ENGINE - FUEL AND CONTROL - NEW FUEL DIVERTER AND RETURN VALVE ASSEMBLY WITH NEW CAP SEAL AND ENLARGED SOLENOID ORIFICE - CATEGORY CODE 5 - MOD.ENG-73-0054

V2500-ENG-73-0054

No. 13298-73-003

ENGINE - FUEL AND CONTROL - NEW FUEL DIVERTER AND RETURN VALVE ASSEMBLY WITH NEW CAP SEAL AND ENLARGED SOLENOID ORIFICE

Replacement of the Fuel Diverter and Return Valve (FDRV)
Fig.1

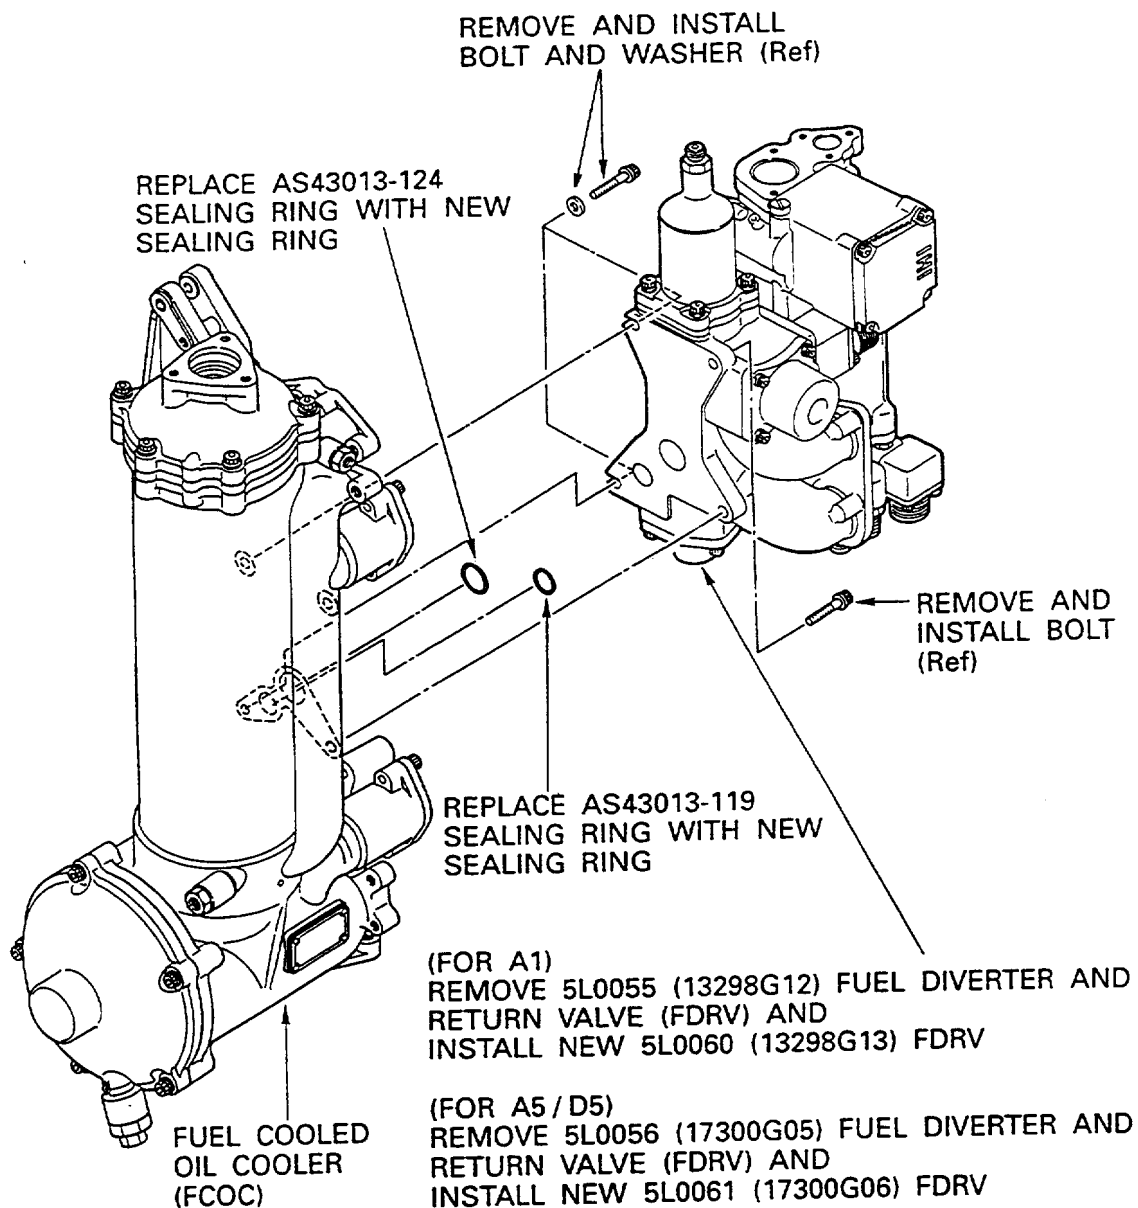
- (a) Remove the existing 5L0055 (13298G12), FDRV from the FCOC as specified in the A320 Engine Manual, 72-00-32, Removal-20 TASK 72-00-32-050-013.
- (b) Install the new 5L0060 (13298G13), FDRV to the FCOC as specified in the A320 Engine Manual, 72-00-32, Installation-20, TASK 72-00-32-450-013.

- (a) Remove the existing 5L0056 (17300G05), FDRV from the FCOC as specified in the A321 Engine Manual, 72-00-32, Removal-20, TASK 72-00-32-050-013.
- (b) Install the new 5L0061 (17300G06), FDRV to the FCOC as specified in the A321 Engine Manual, 72-00-32, Installation-20, TASK 72-00-32-450-013.

- (a) Remove the existing 5L0056 (17300G05), FDRV from the FCOC as specified in the McDonnell Douglas (MD-90) Engine Manual, 72-00-32.
- (b) Install the new 5L0061 (17300G06), FDRV to the FCOC as specified in the McDonnell Douglas (MD-90) Engine Manual, 72-00-32.

Location of the Cap Seal and Solenoid Assembly
(Additional, Old and New Part Configuration)
Figure 1

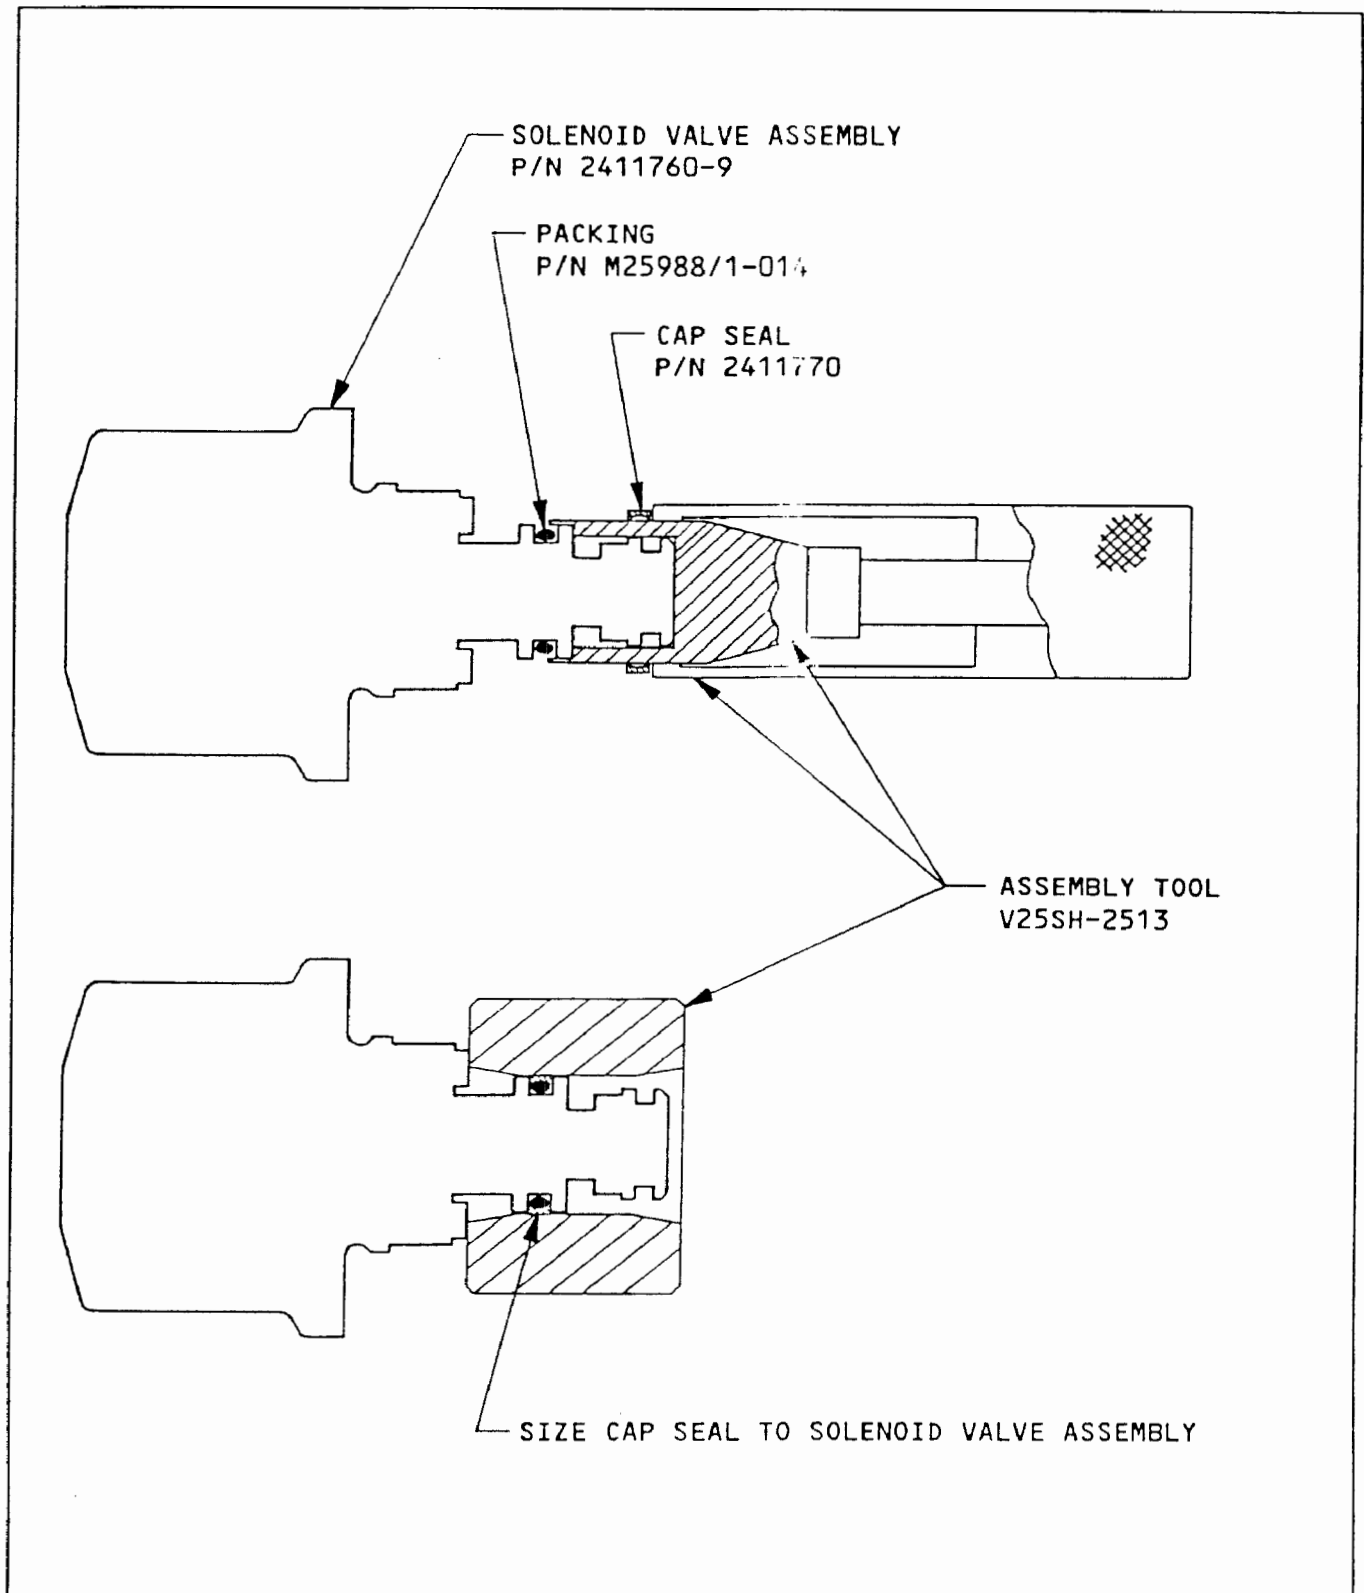
- (f) Remove the M25988/1-119, M25988/1-014 and M25988/1-013, installed packing on solenoid assembly (Refer to Figure 1).
- (g) Install the M25988/1-014, packing on to the solenoid assembly.

INSTALL THE 2411770, CAP SEAL (1 Off)
ON PACKING (245).

REPLACE THE EXISTING PN 2411760-7 SOLENOID ASSEMBLY (1 Off),
WITH THE NEW PN 2411760-9 SOLENOID ASSEMBLY (1 Off).

Installation of Cap Seal
Figure 2

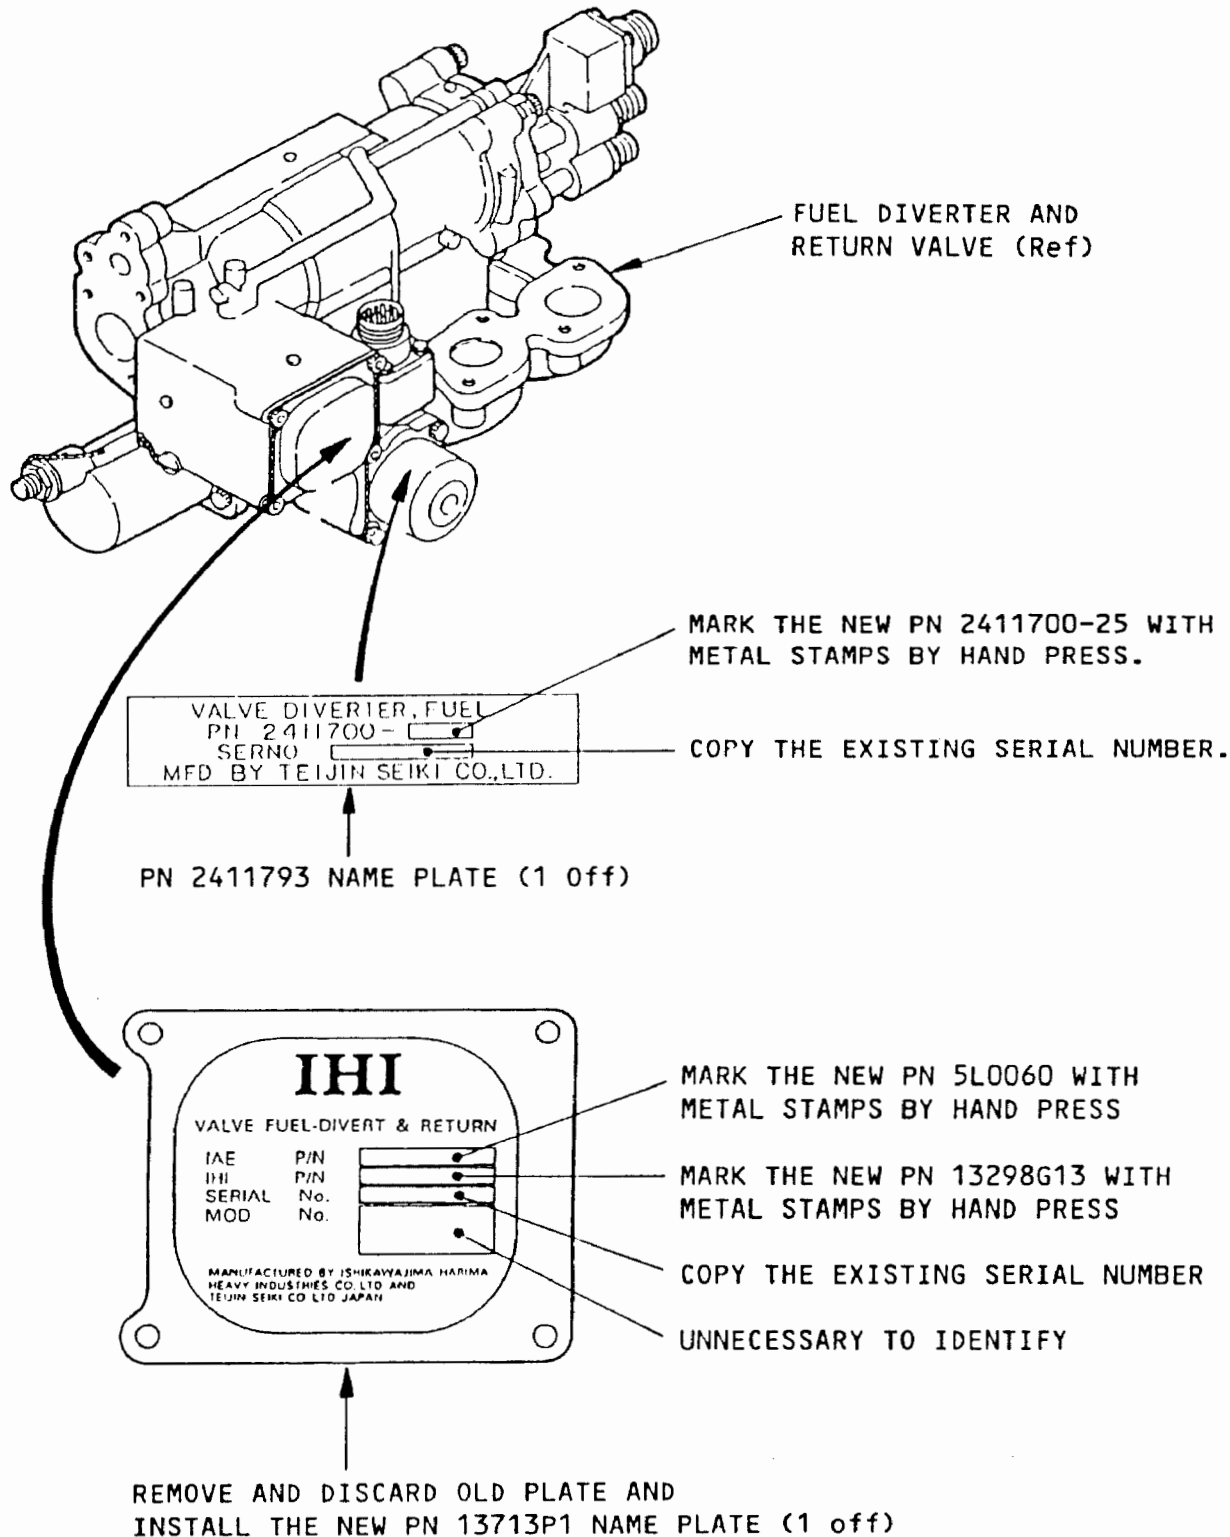
- (h) Install the 2411770, cap seal on the M25988/1-014, packing using V25SH-2513, assembly tool (Refer to Figure 2).
- (i) Do a cap seal sizing to solenoid assembly using V25SH-2513, assembly tool (Refer to Figure 2).

Response Time of the FDV - Test Condition
Figure 5

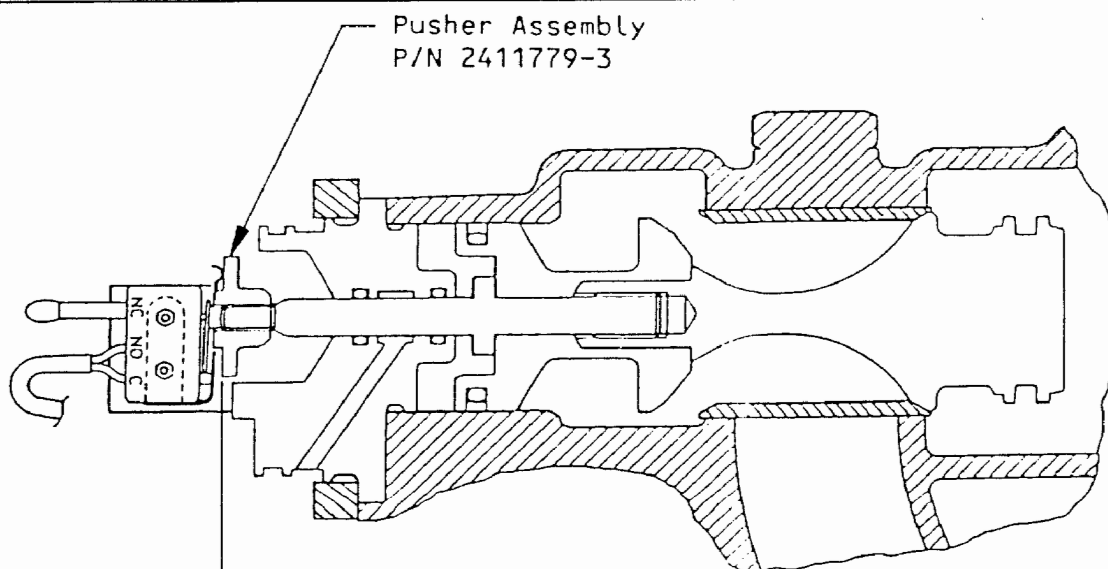
1 The unit shall be installed in the setup similar to that shown in Figure 5. Flow and pressure shall be set as shown in condition 1 and 2. The pressure at port 5 or the FDV stroke and the voltage signal to the solenoid shall be monitored and recorded with Time-Scale, as the unit is energized and de-energized.

- (1) Supply the applicable pressure in to the HP (Port 9) side (550 psig) and reduce the pressure from the LP (Port 10) side (221 psig), adjust by the needle valve (solenoid de-energized).
- (2) Measure the change-over time from receipt of the voltage signal to completion of valve travel shall be 0.24 sec. to 1.50 sec. and measure the FDV stroke using slide calipers.
- (3) Make sure that FDV moves full stroke in comparison with recorded FDV full stroke (dimension A) in paragraph (r), (iv), 3.

- (1) Supply the applicable pressure in to the HP (Port 9) side (550 psig) and reduce the pressure from the LP (Port 10) side (205 psig), adjust by the needle valve (solenoid energized).
- (2) Measure the change-over time from receipt of the voltage signal to completion of valve travel shall be 2.40 sec. to 4.10 sec. and measure the FDV stroke using slide calipers.
- (3) Make sure that FDV moves full stroke in comparison with recorded FDV full stroke (dimension A) in paragraph (r), (iv), 3.

Measurement of FDV Full Stroke
Figure 6

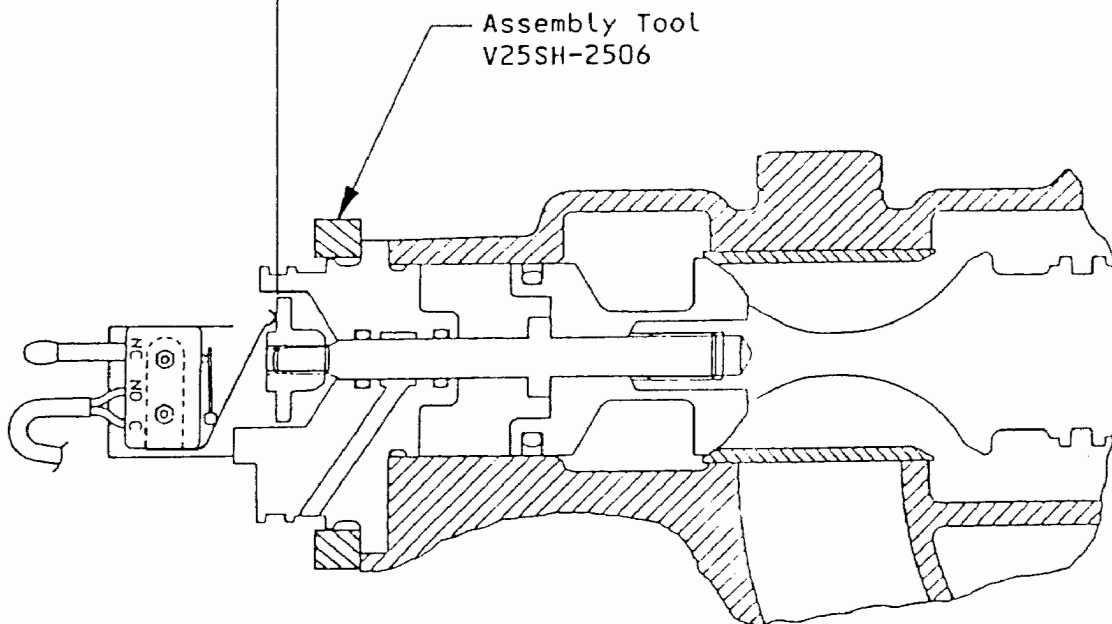
- (1) Measure the FDV full stroke (dimension A, in figure 6) using slide calipers with solenoid de-energized condition and solenoid energized/supplying the applicable pressure in to the HP (port 9) side (550 psig) condition. Note the FDV full stroke.

Location of the Cap Seal
(Additional New Part Configuration)
Figure 1

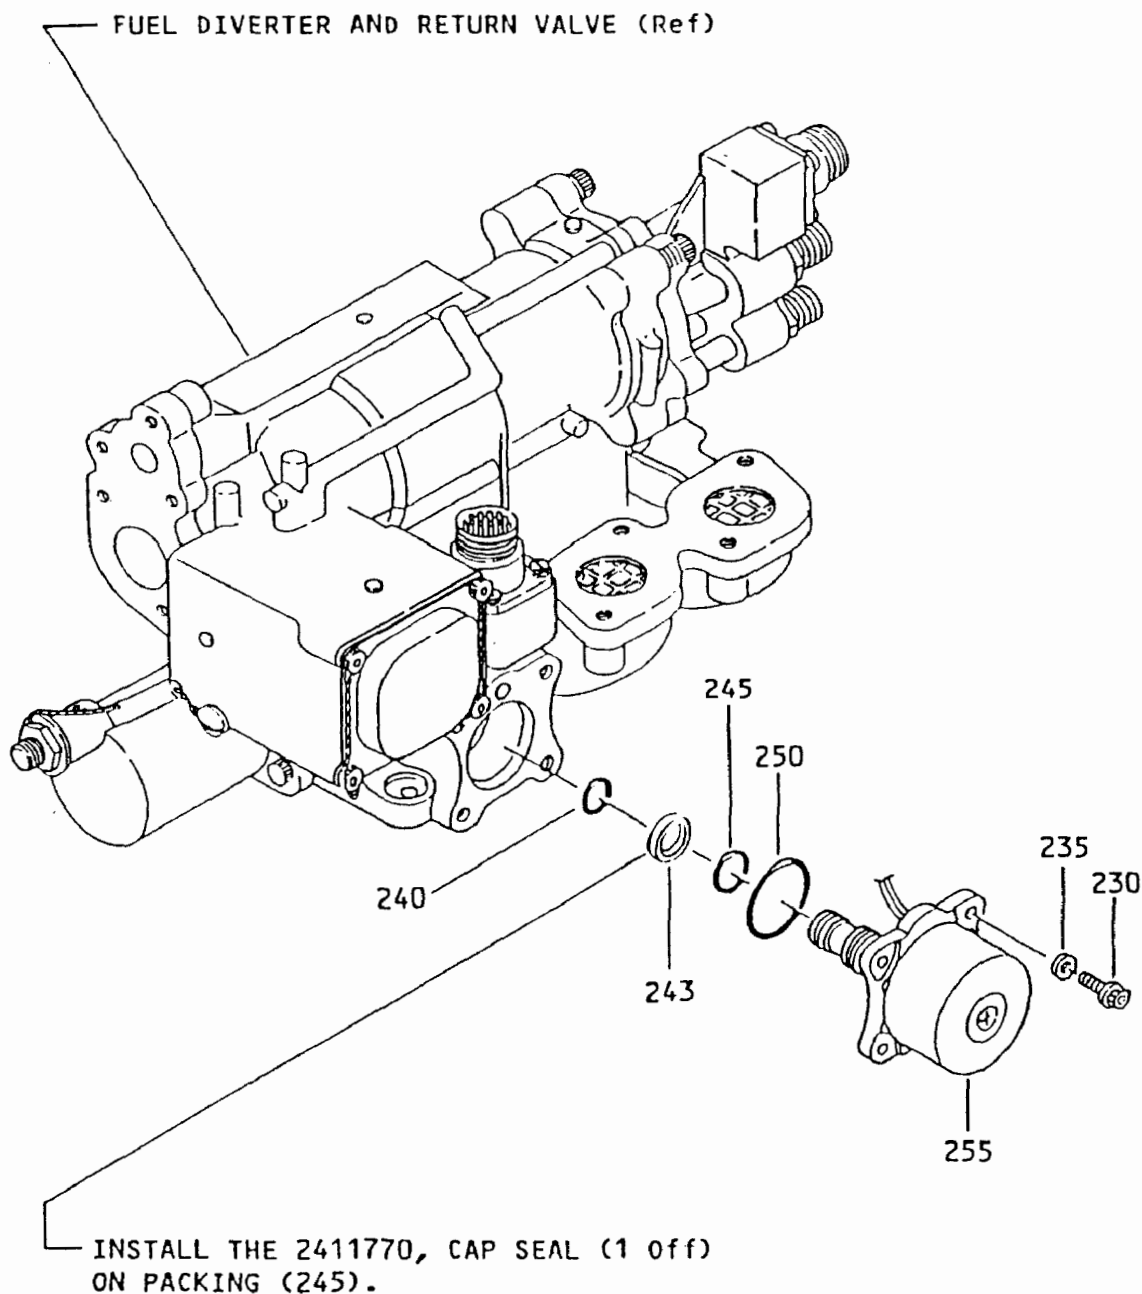
- (e) Remove the M25988/1-119, M25988/1-014 and M25988/1-013, installed packing on solenoid assembly (Refer to Figure 1).
- (f) Install the M25988/1-014, packing on to the solenoid assembly.

Installation of Cap Seal
Figure 2

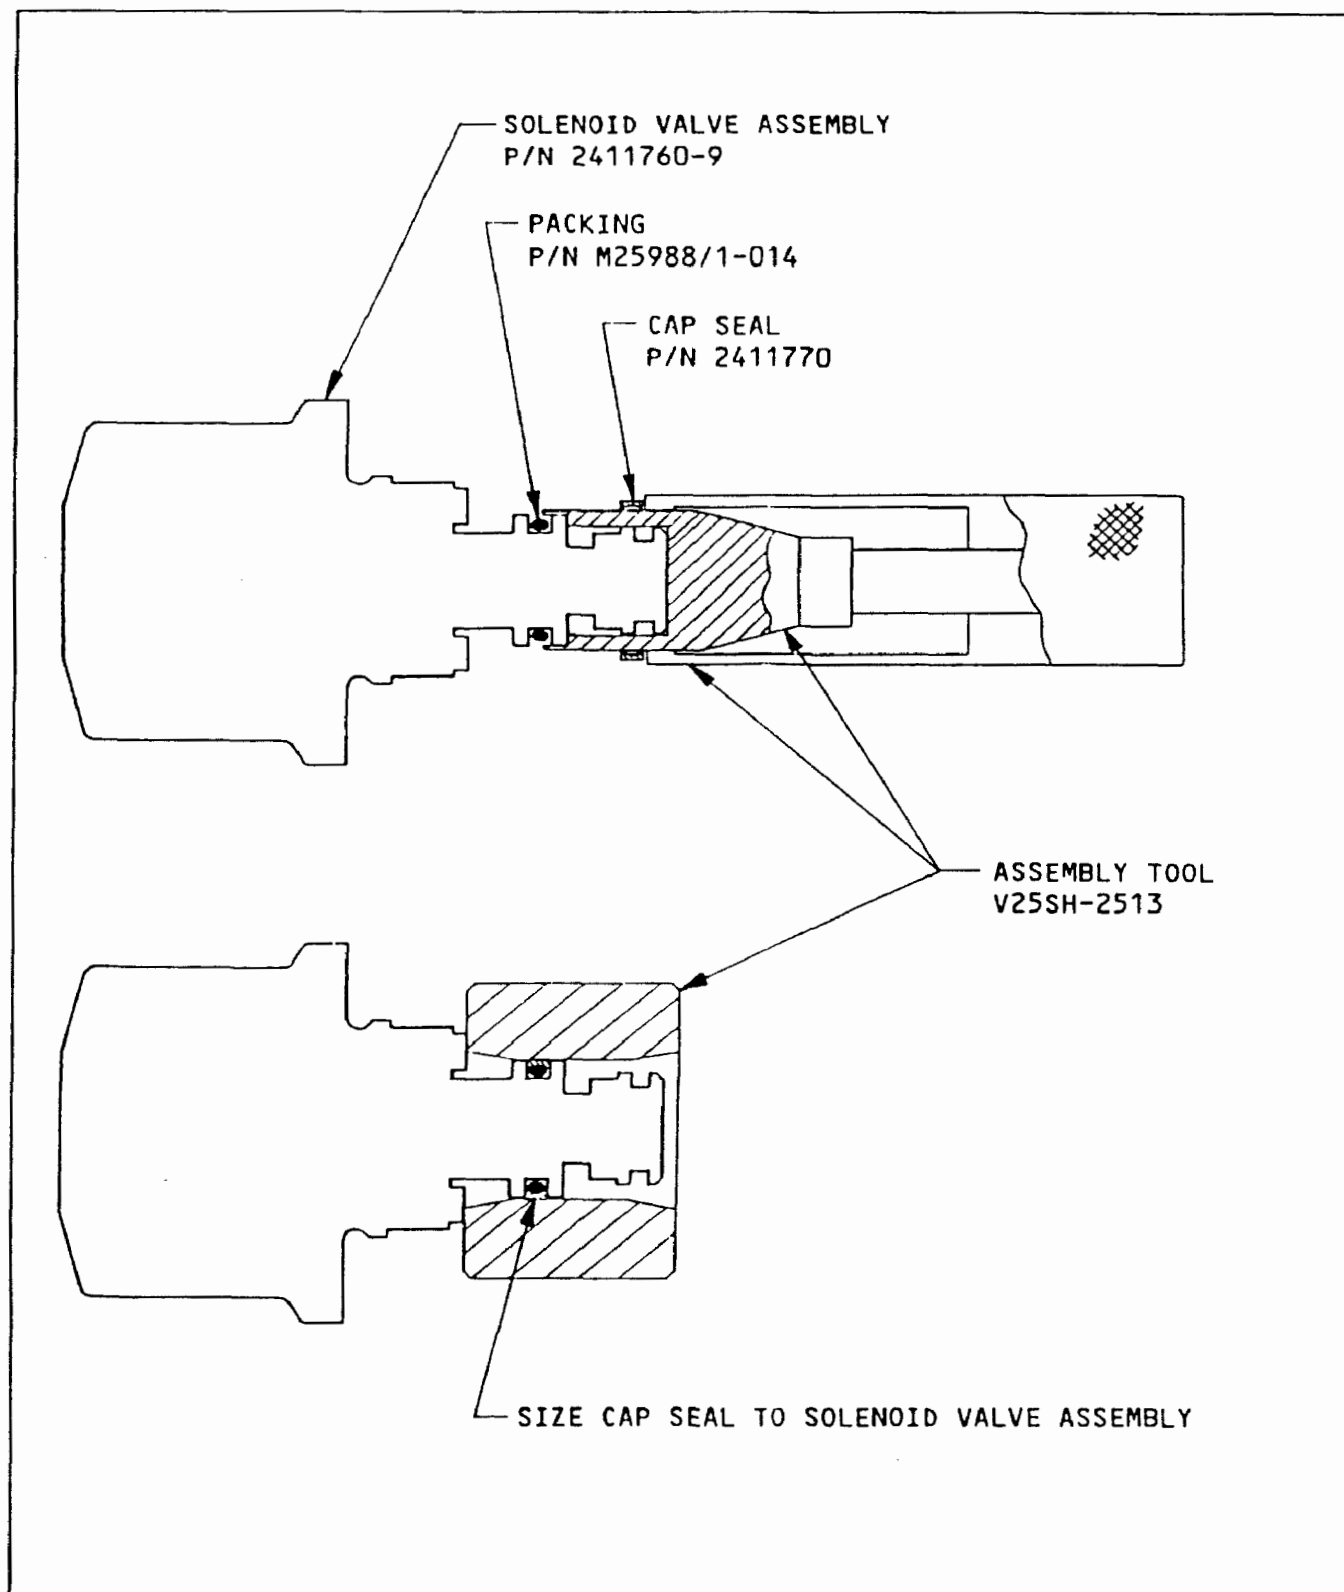
- (g) Install the 2411770, cap seal on the M25988/1-014, packing using V25SH-2513, assembly tool (Refer to Figure 2).
- (h) Do a cap seal sizing to solenoid assembly using V25SH-2513, assembly tool (Refer to Figure 2).
